| Project Title: | Fountain Wind Project |
| Document Title: | LU-002_LandUses1mile |

Fountain Wind Project Response to CEC Data Request LU-002

Follow-up Data Request LU-002:

Land Uses within 1 mile of the Project Site Boundary

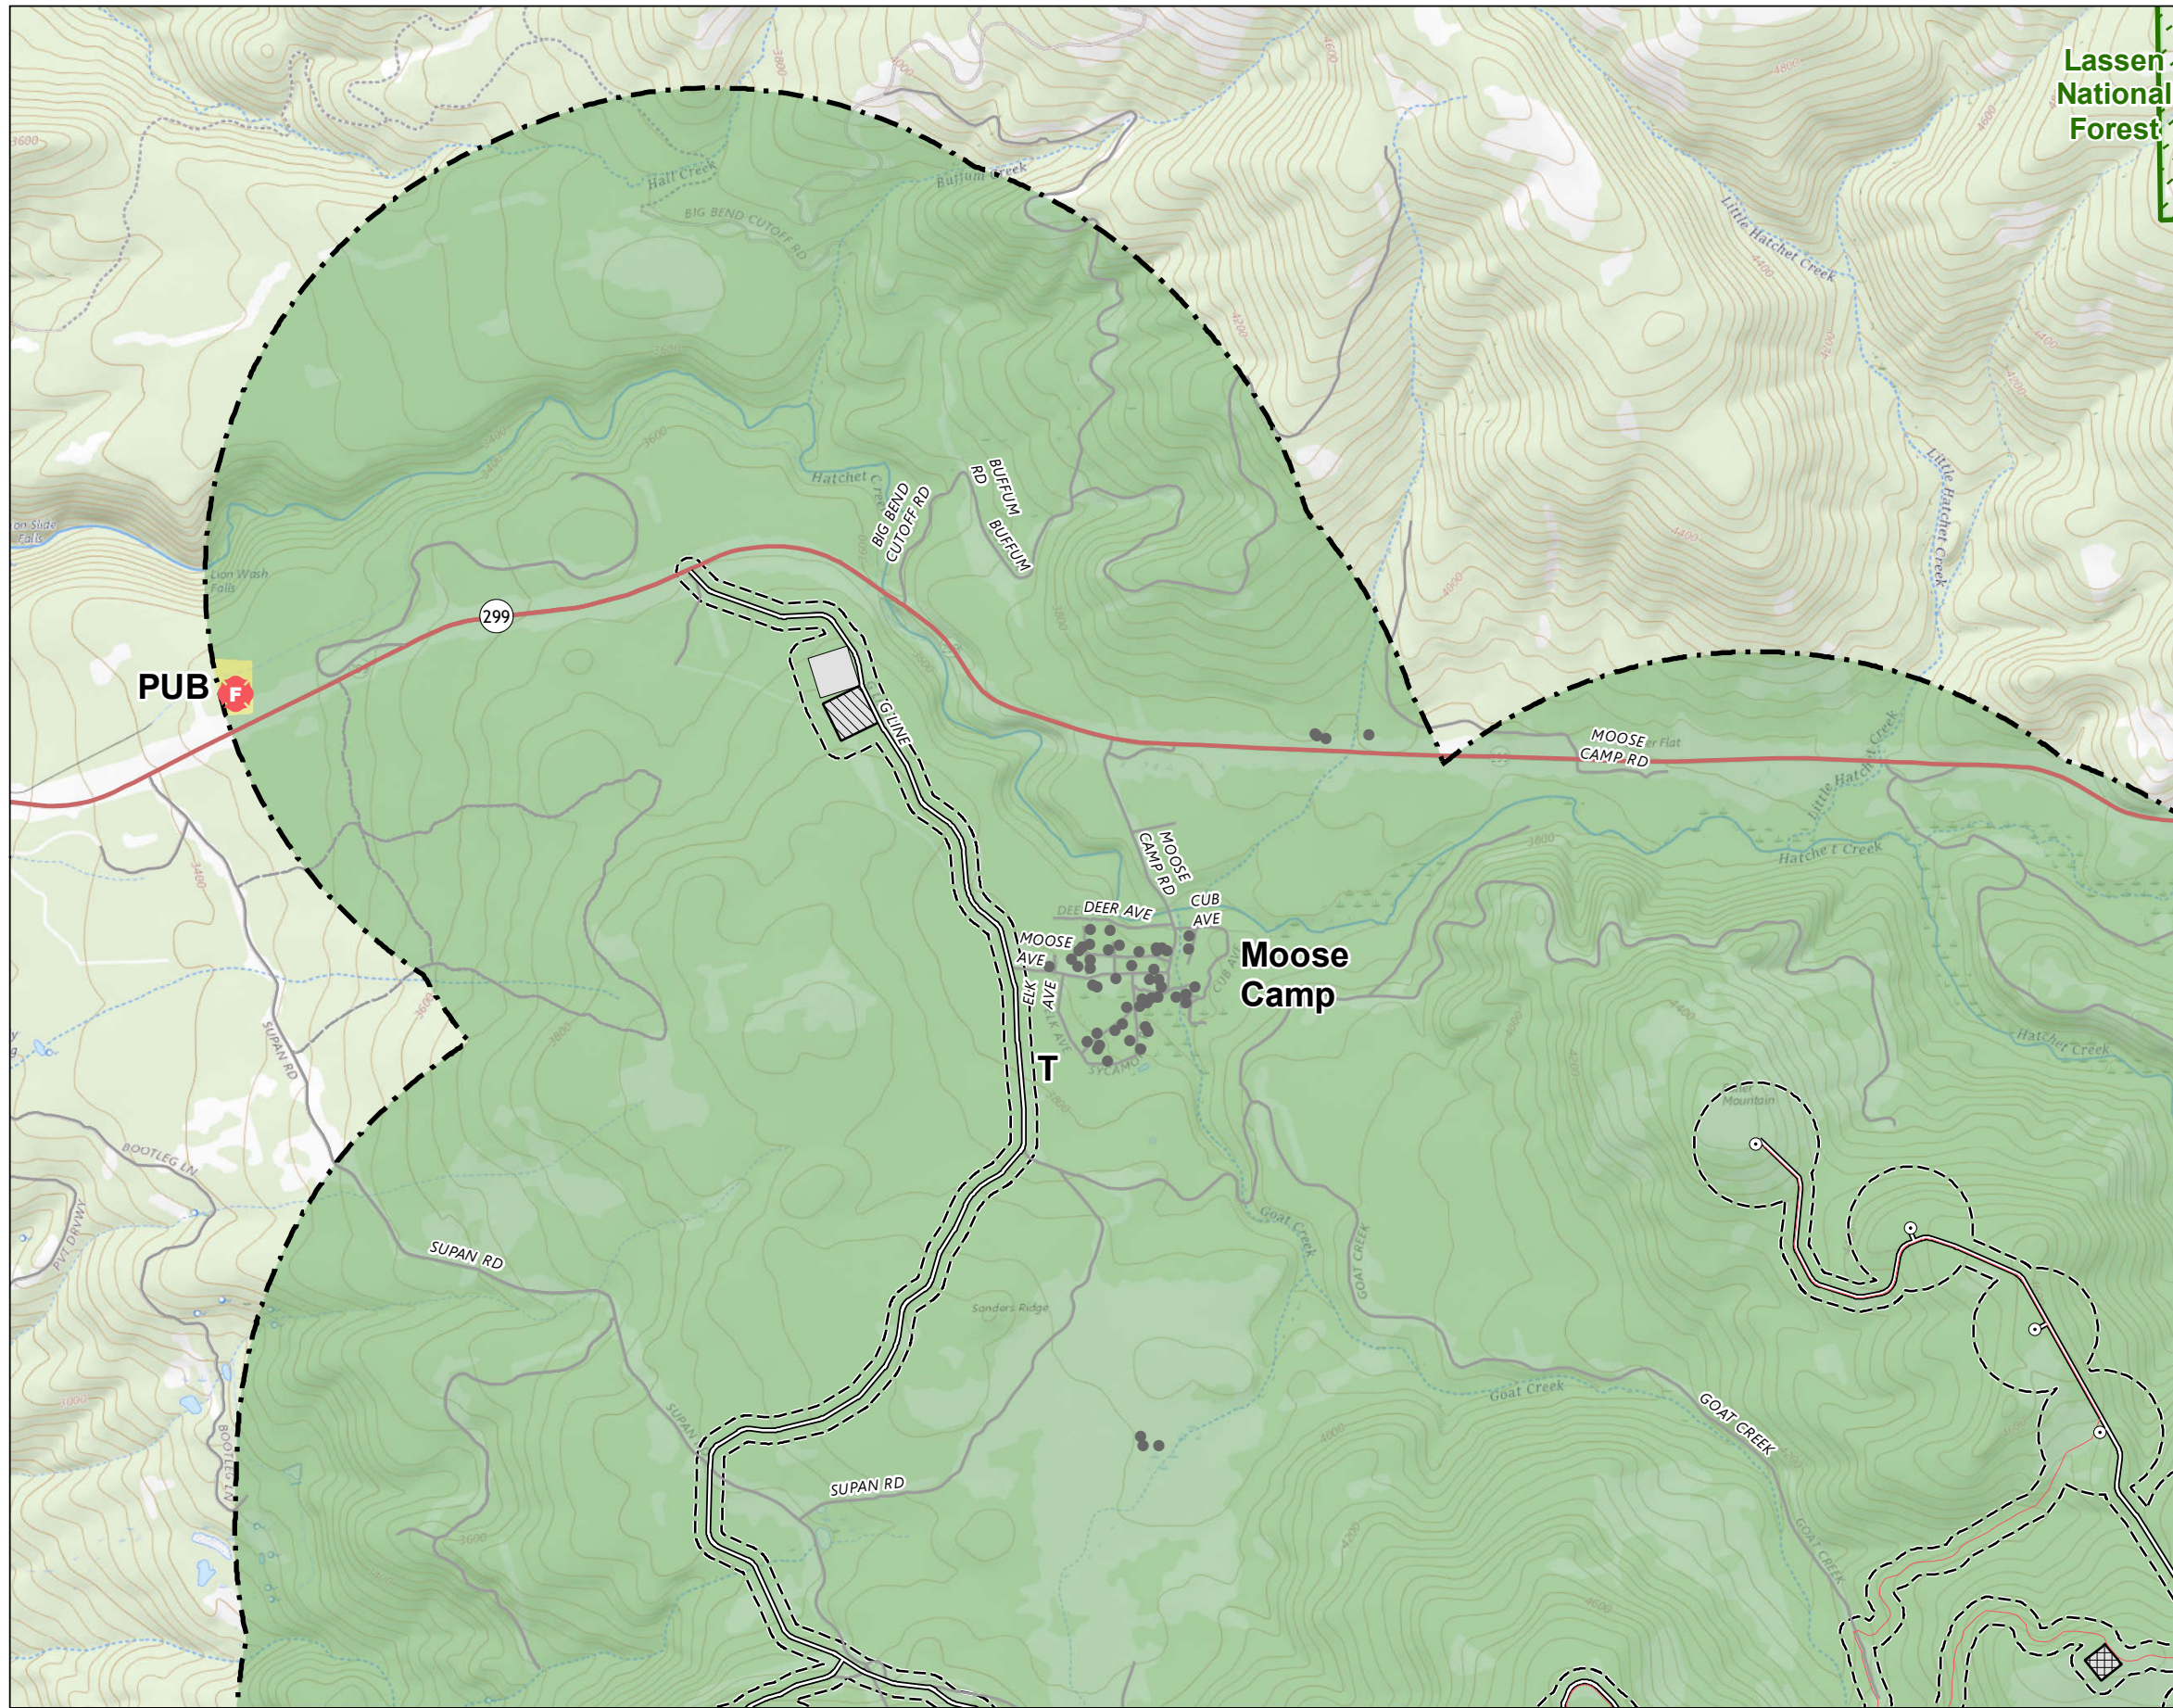
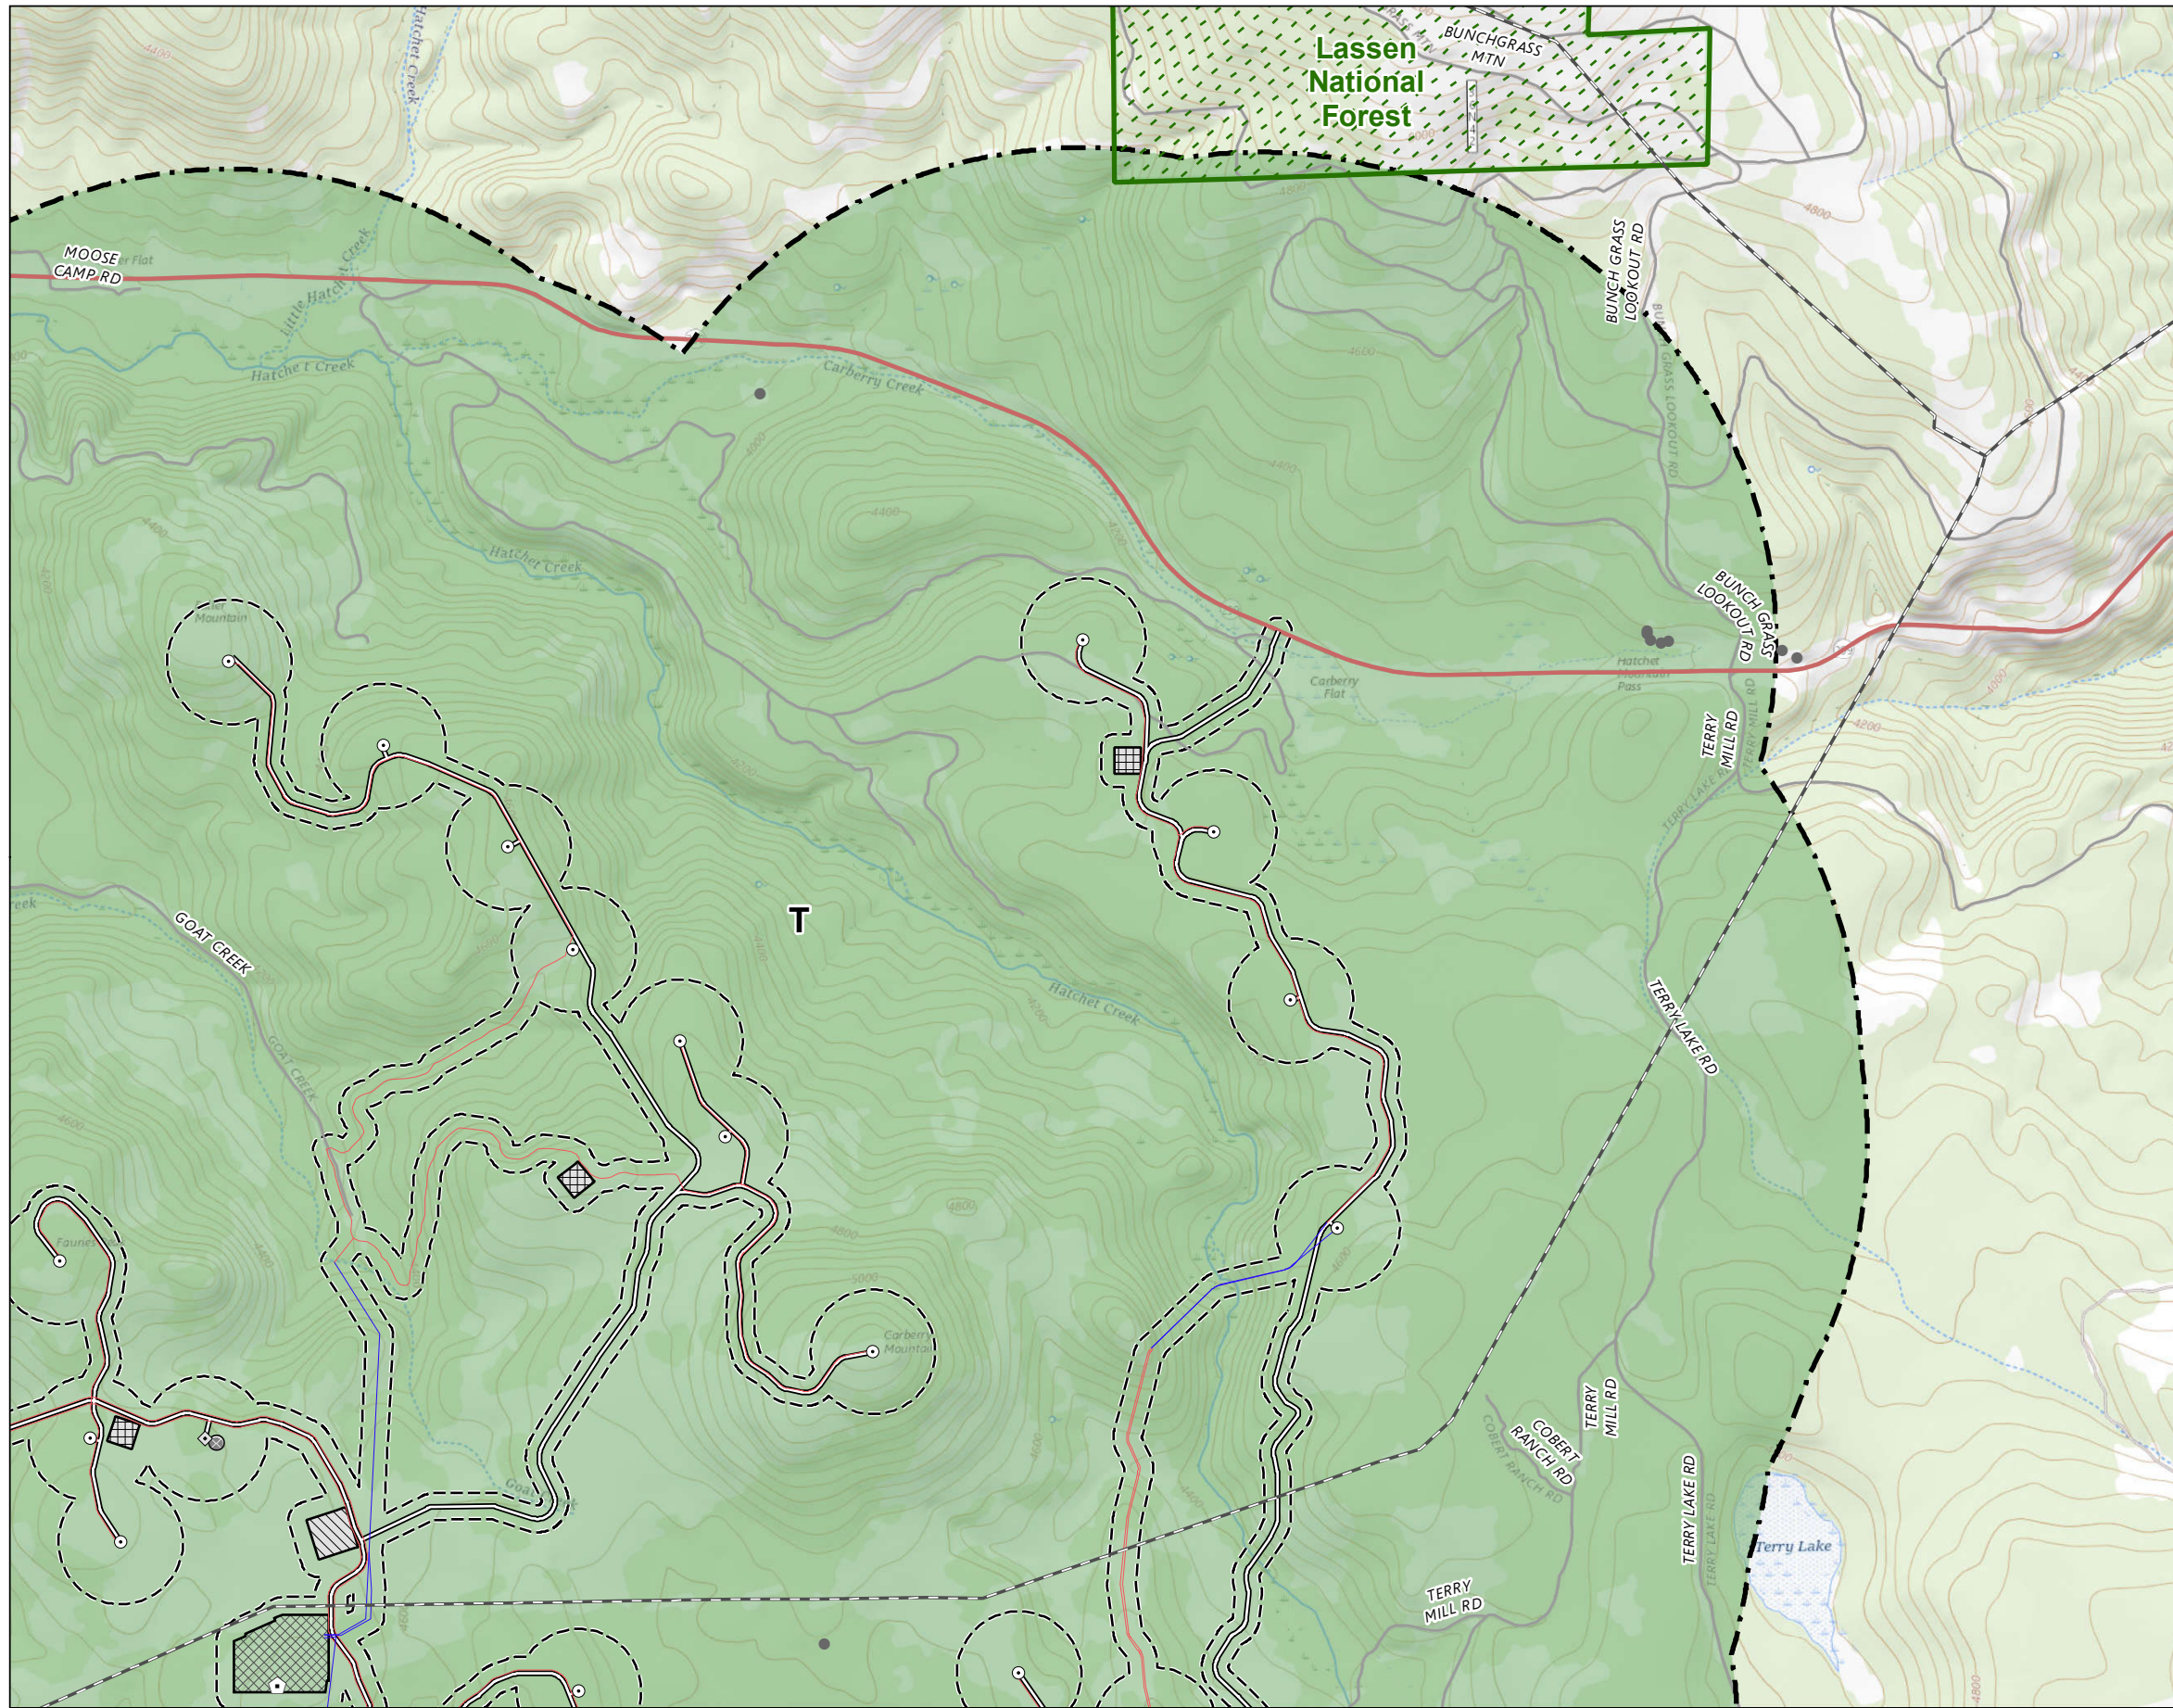
The information submitted is incomplete. TN 250283 (LU-02_LandUse) and TN 250448 (land_use_fwp_responses) are not adequate responses to the Warren-Alquist Act Siting Regulations Appendix B (g)(3)(A) and Appendix B (g)(3)(A)(i).

- The Project Site Boundary (i.e., the boundary that encompasses all project activities).
- The 1-mile buffer from the specific proposed Project Site Boundary, as required by the Warren-Alquist Act Siting Regulation Appendix B (g)(3)(A). The “buffer” illustrated in TN 250283 is not accurately shown as extending 1-mile from the project boundary. Note that a “project area” is not a specific project site boundary. The Applicant needs to provide the specific boundary upon which the Project would be sited to allow for CEQA impact analysis.

- The location of zoning designations that are identified in the figure legend for TN 250283 (i.e., Rural Residential is shown in the legend but is missing on the figure).

- Per the Warren-Alquist Act Siting Regulation Appendix B (g)(3)(A)(i), a discussion of existing physical land uses within the Project Site Boundary and 1-mile buffer area that include “residential, commercial, industrial, recreational, scenic, agricultural, natural resource protection, natural resource extraction, educational, religious, cultural, and historic areas, and any other area of unique land uses.” This discussion must include a description of the total numbers and locations of any existing residences; recreation facilities such as parks & trails; schools; commercial/retail sites; industrial uses or other land uses. Note that land use designations (i.e., general plan and zoning) are not the same as existing physical land uses currently occurring on the project site.

See revised figure LU-002. The Project Site Boundary includes all project features and all areas in which ground disturbing activities could potentially occur, and the associated construction and maintenance corridors and is depicted on Figure LU-002. Appendix B does not require an applicant to provide the total numbers of existing residences but the Applicant nonetheless estimates that there are approximately 50 rooftops that may be houses in the second home community of Moose Camp, and an additional 15 or so scattered throughout the 1-mile buffer. The remaining physical land uses are included in the table below.
